REVISED RESPONSE TO REQUEST FOR ADDITIONAL INFORMATION

APR1400 Design Certification

RAI No.: 255-8285
SRP Section: 03.08.05 - Foundations
Application Section: 03.08.05
Date of RAI Issue: 10/19/2015

Question No. 03.08.05-4

Figure 1 Typical Detail for Installation of Waterproofing Membrane

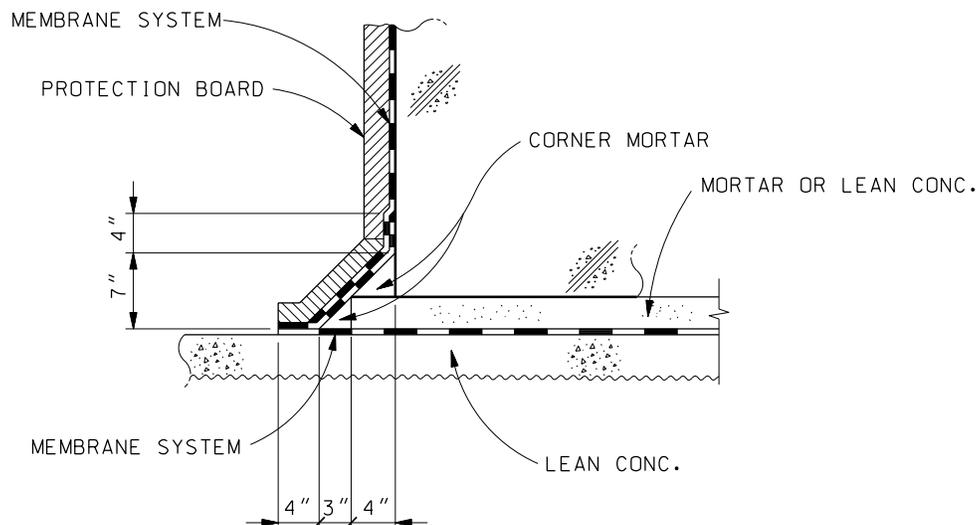
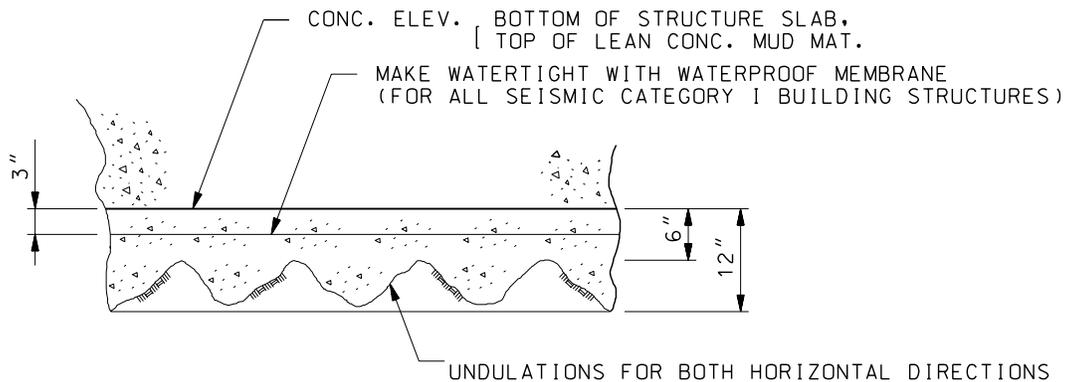
Applicant is requested to describe, whether waterproofing membranes are used in APR1400 design, and if used, provide effects on the shear resistance of the NI common basemat.

Typical detail for installation of the waterproofing membranes is shown in Figure 1. Because the membranes are installed between lower and upper lean concrete beneath the basemat, they affect the shear resistance of the NI common basemat.

The sliding by shear transfer may be considered across the interfaces between dissimilar materials, i.e., foundation concrete on lean concrete, lean concrete and waterproofing membrane, lean concrete and the supporting medium (soil or rock), and within the supporting medium.

The coefficient of friction between the lean concrete and waterproofing membrane is **greater than or equal to** 0.55 as described in COL 3.8(13). This value is compared with the coefficients of friction between other interfaces, and the minimum value among them is used for stability check of the basemat.
